Summary of Items Discussed in 4/2017 APSEC Discussion Forum on 11 August 2017

Diagram B3: Open Plan Layout

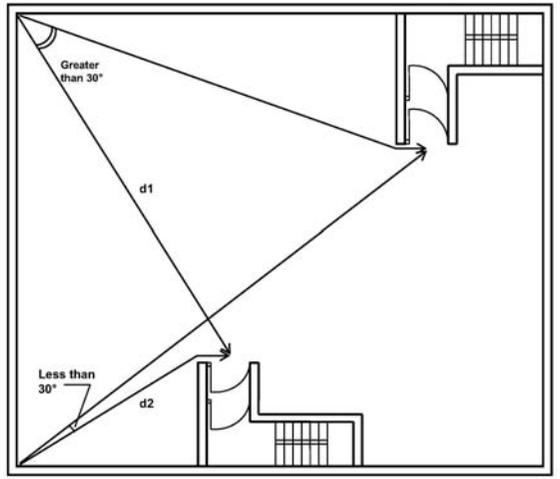
Figure B3 of FS Code shows how to comply when the angle to the 2 exits from a point in the storey is less than 30 degree.
It seems that the wordings in this paragraph are in conflict with provisions for deadend travel distance in the COP. Please consider to review.

BD advised that figure B3 basically showed the intention of the requirements. Clause B11.6 of the FS Code was being reviewed and results would be promulgated in due course with other revisions.
